LOS ANGELES RIVER MASTER PLAN
 Negative Declaration/Environmental Assessment

**FIGURE 5.1-1
 MAIN LOT MASTER PLAN**

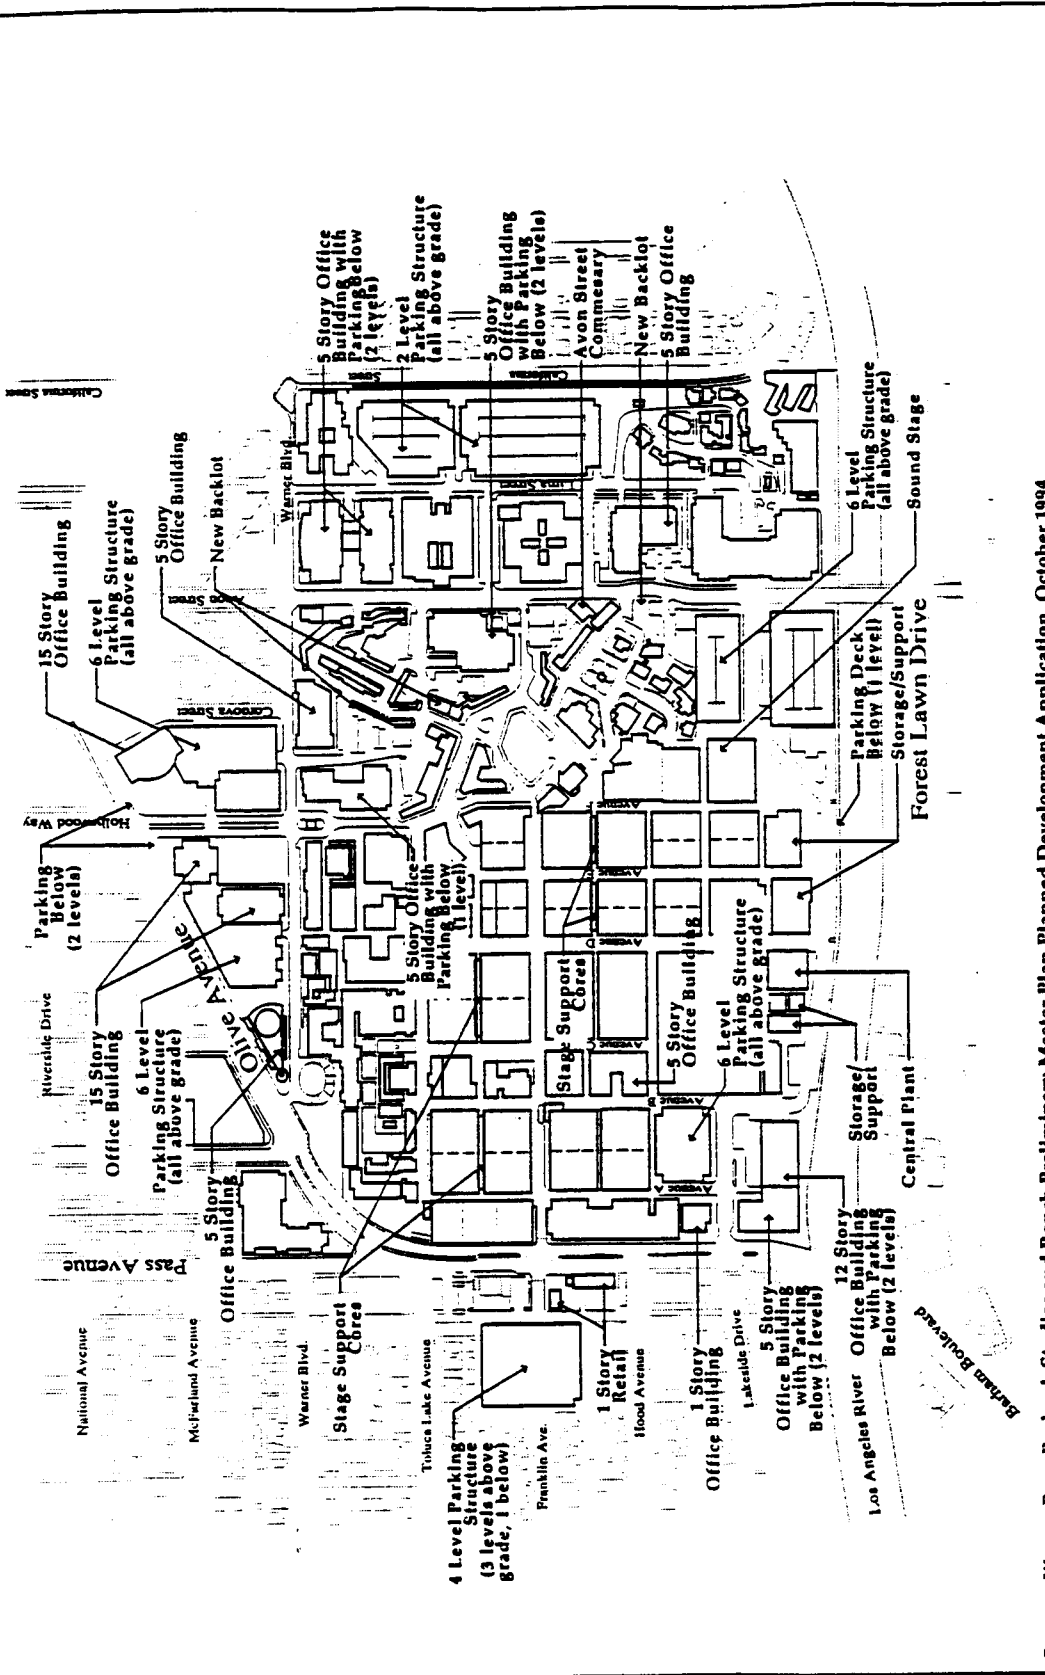
- Section 5.1.1, (Page 5-5) Add to the Local subsection after "City of Burbank (1992)", "City of Burbank (1995).
- Section 5.1.2, (Page 5-7) Add after first sentence in Reach Number 4 - Glendale Narrows Subsection, "The City of Burbank circulated *Draft Environmental Impact Report for the Warner Bros. Studios Main and Ranch Lot Master Plans* for public in May 1995. The EIR was certified and the proposed project was approved in September 13, 1995. The approved improvements effect the portion of the *Master Plan* illustrated on Sheet No. 60. The approved project is shown in Figure 5.1-1, Main Lot Master Plan and Figure 5.1-2, Main Lot Plan Overview which have been added to the Programmatic Negative Declaration and Environmental Assessment." Proposed economic development locations shown within the Warner Bros. Studios Main and Ranch Lot Master Plans area have been relocated within the easement area.

FIGURE 5.12-1
 METROPOLITAN WATER DISTRICT OF SOUTHERN CALIFORNIA FACILITY

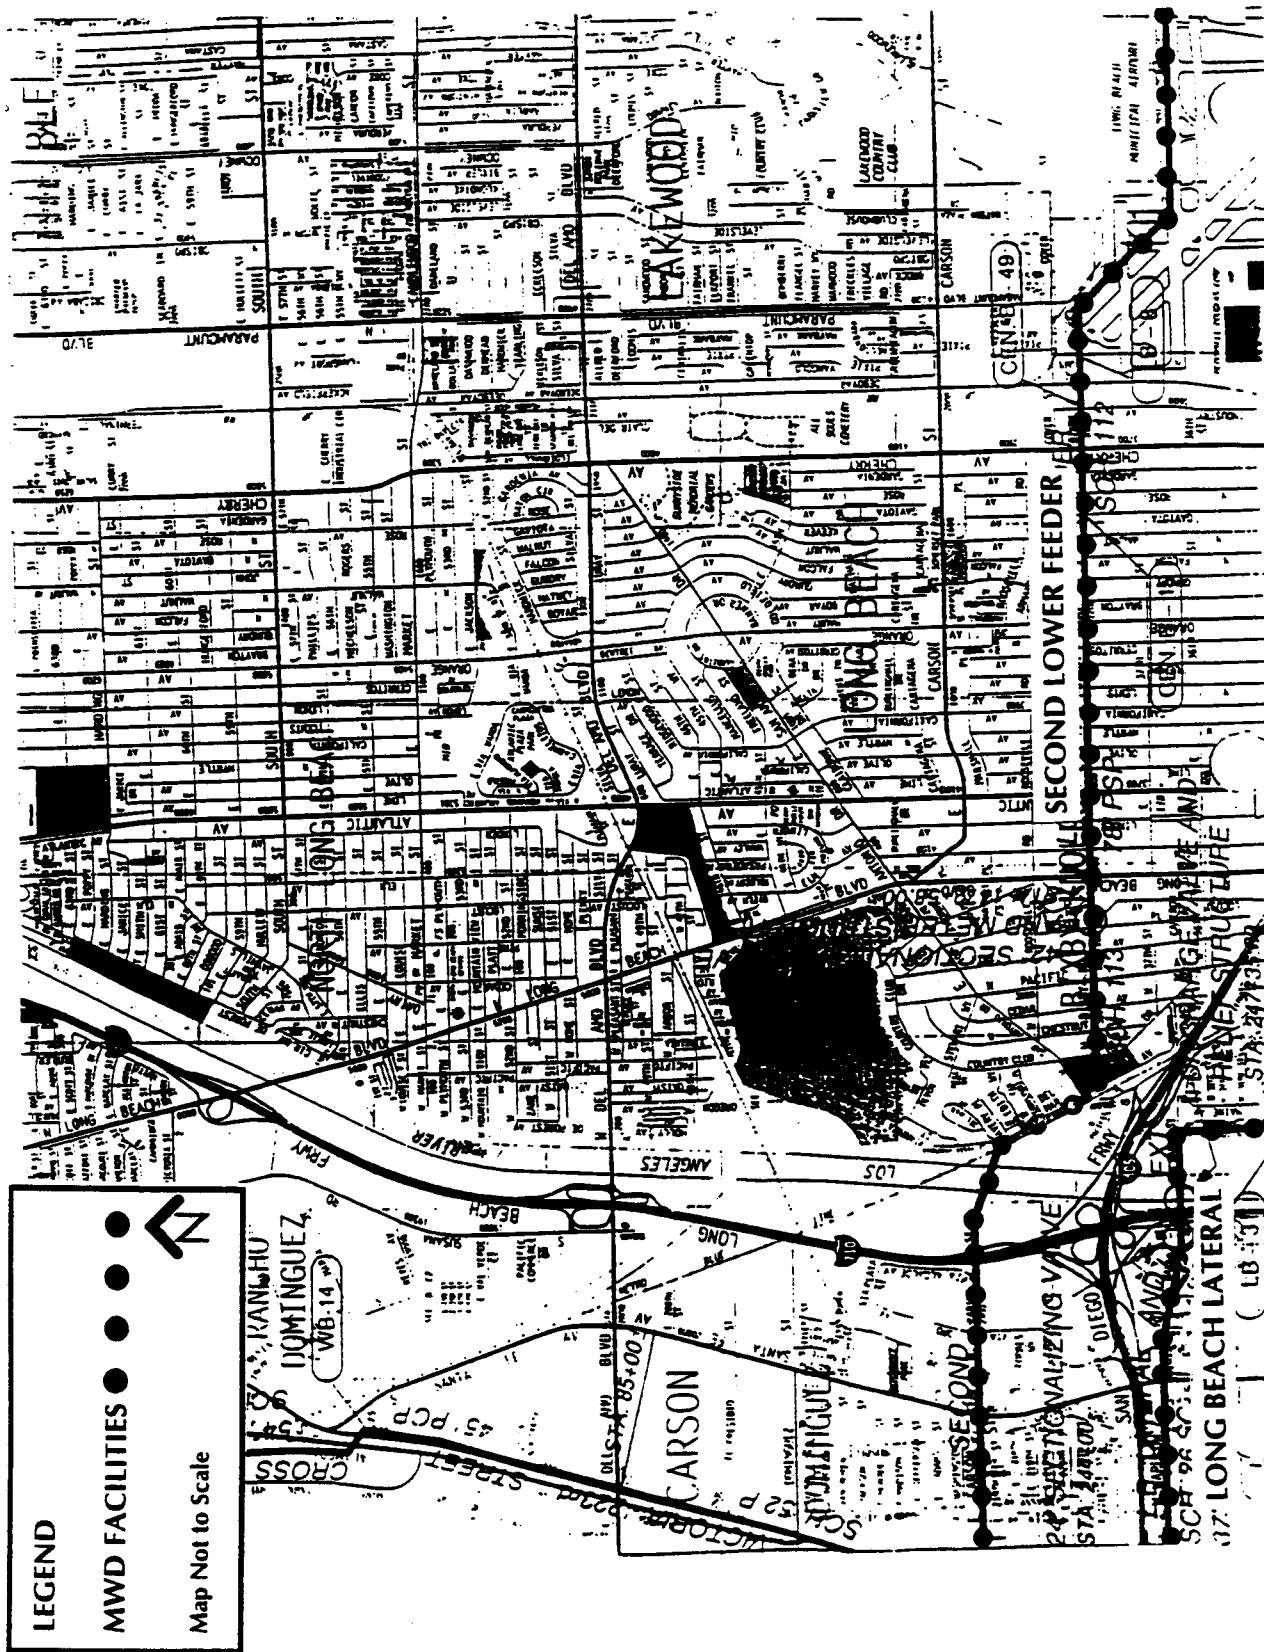
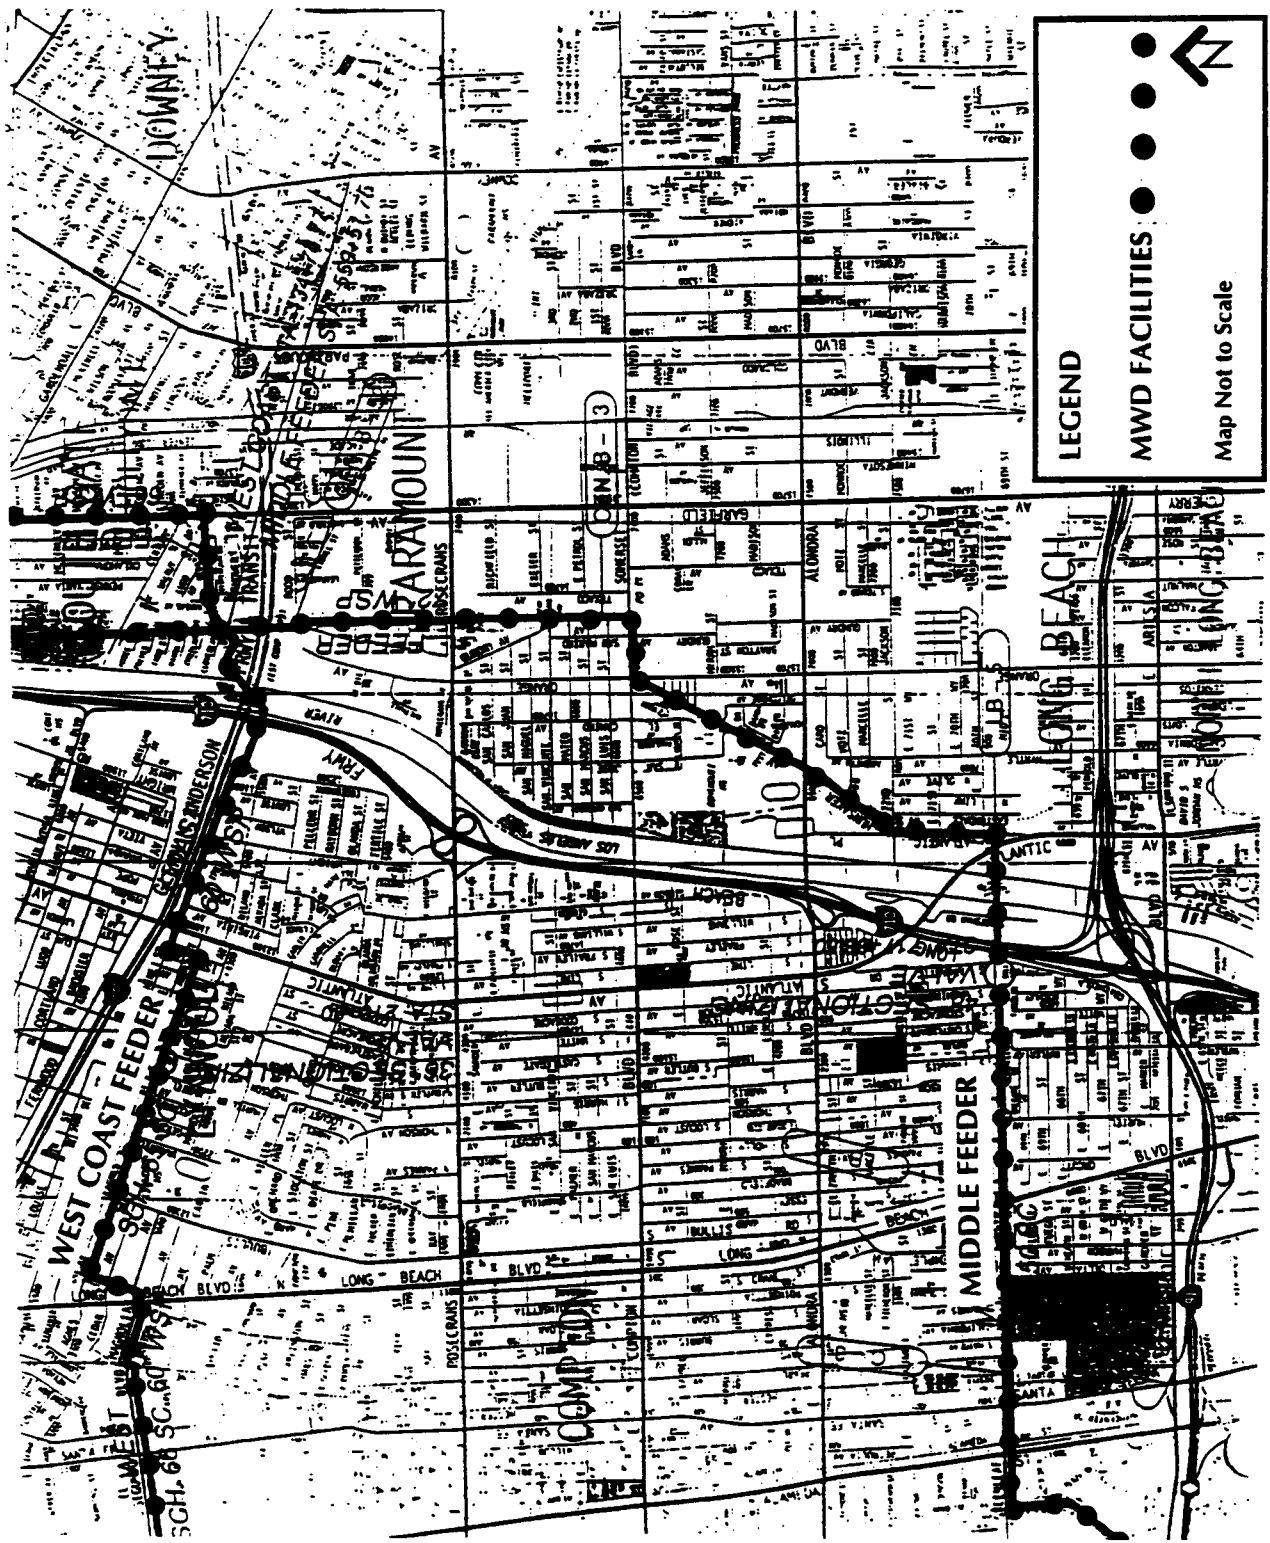
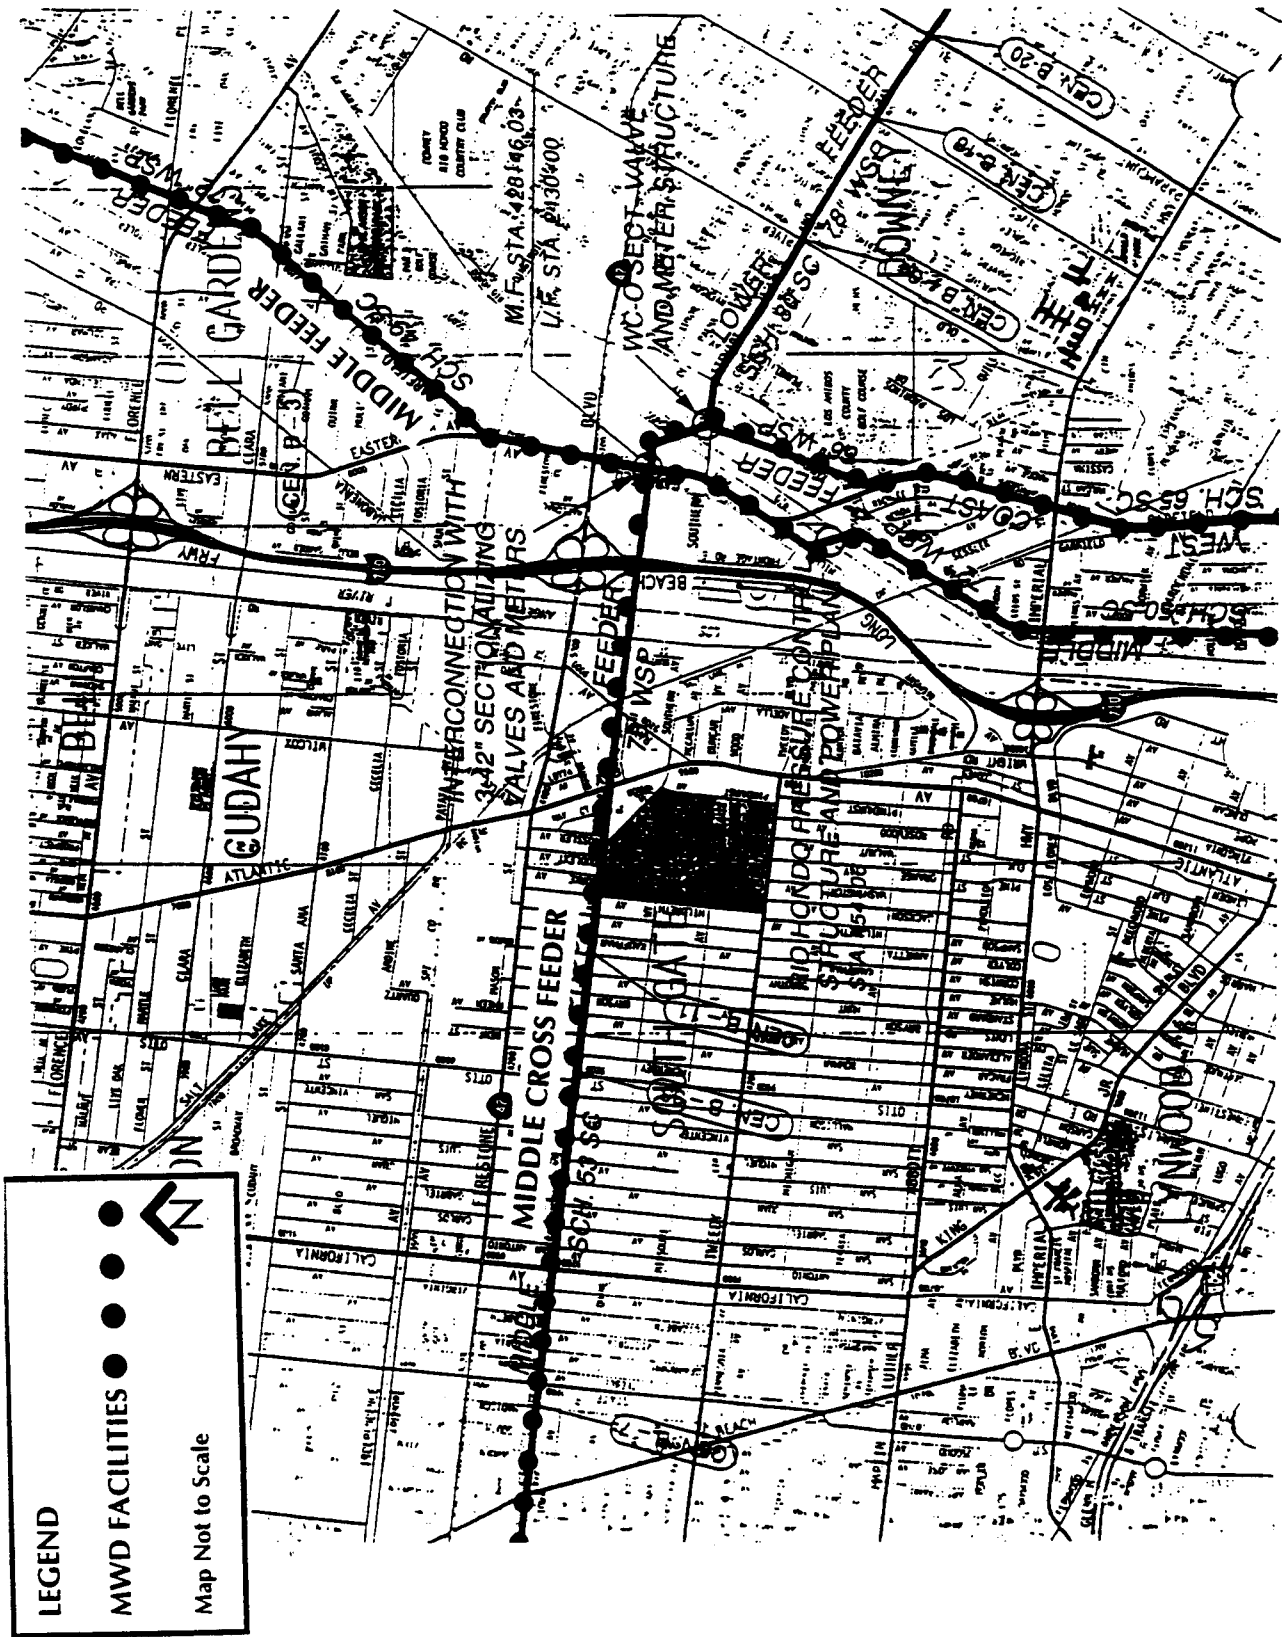
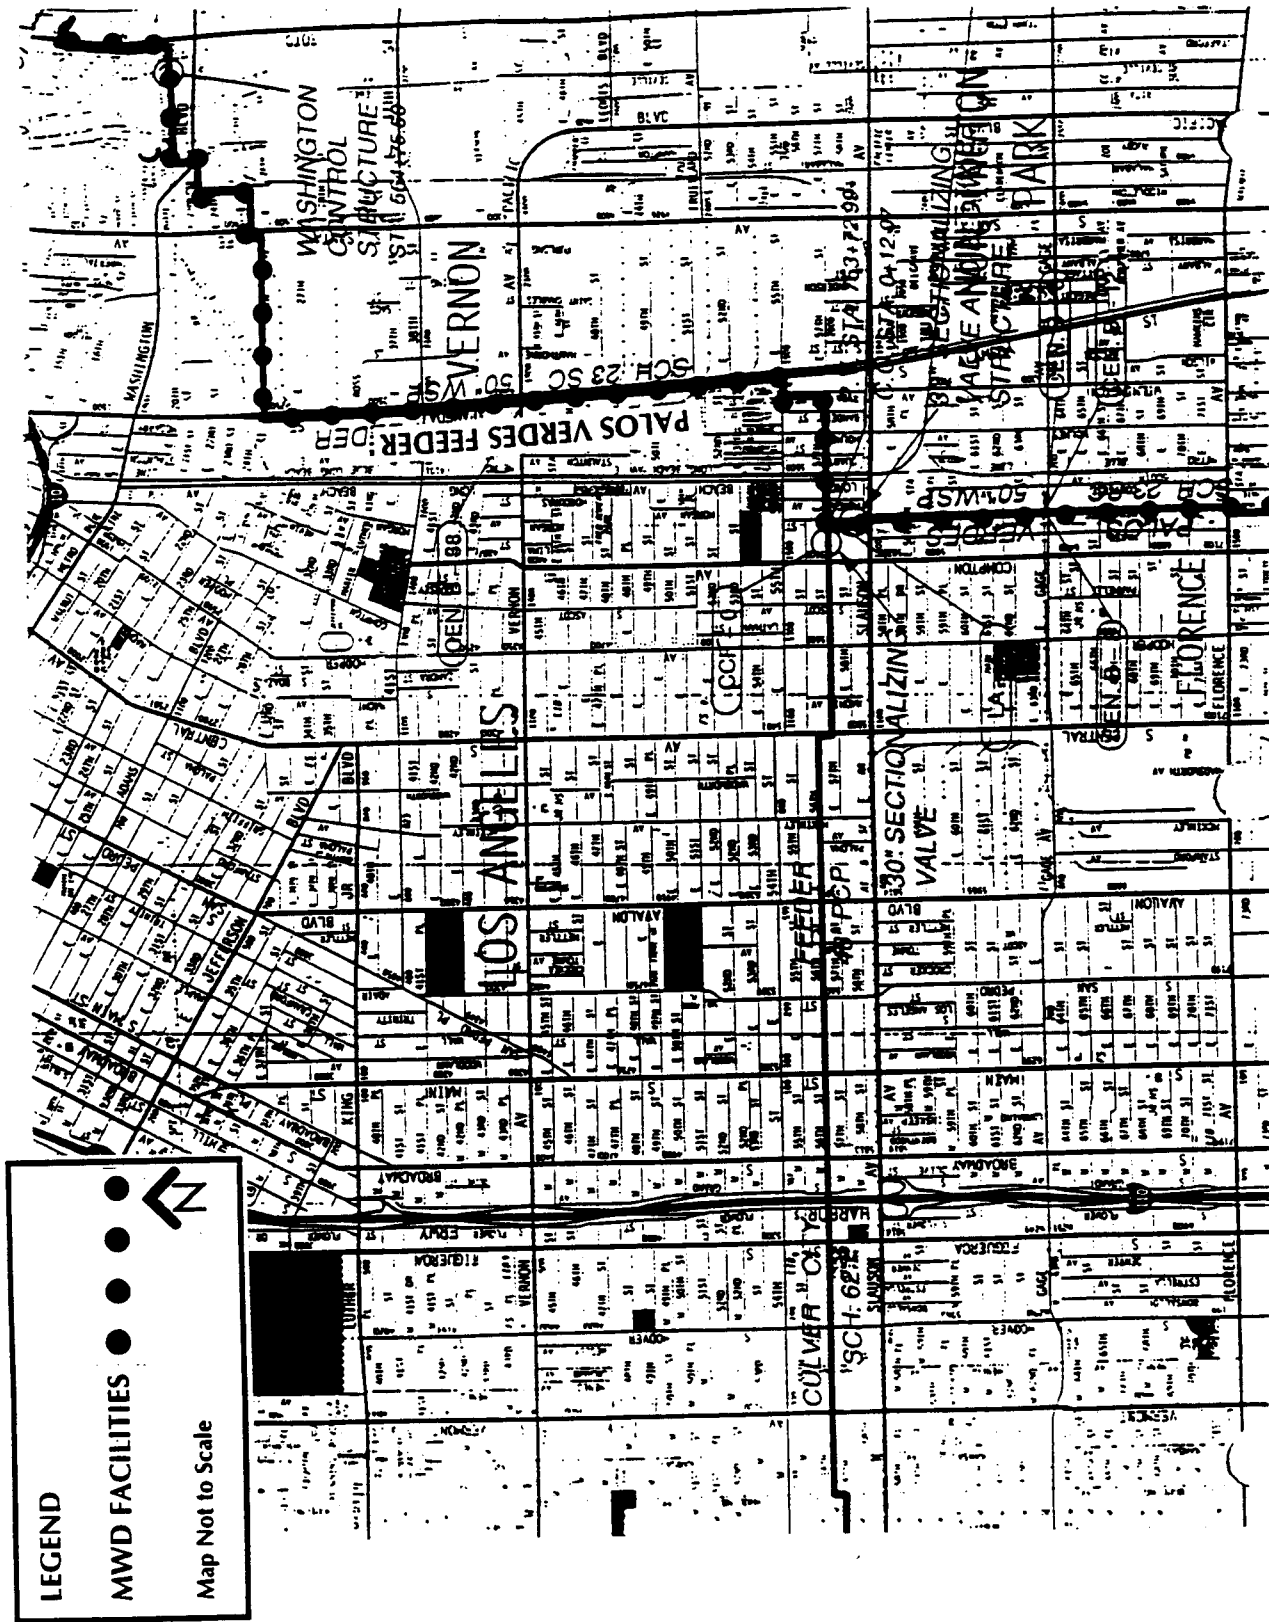
- Section 5.12.2, (Page 5-76a) Add as second paragraph under "Existing Conditions" Section, "In particular, the Metropolitan Water District of Southern California (Metropolitan) has nine facilities in the area of the proposed project. Metropolitan's Long Beach Lateral, Second Lower Feeder, Middle Feeder, West Coast Feeder, Middle Cross Feeder, Palos Verdes Feeder,

Santa Monica Feeder, Sepulveda Feeder, and East Valley Feeder cross or are adjacent to the proposed improvement areas.”

See addition of Figures 5.12-1, 5.12-2, 5.12-3, 5.12-4, 5.12-5, 5.12-6, and 5.12-7.
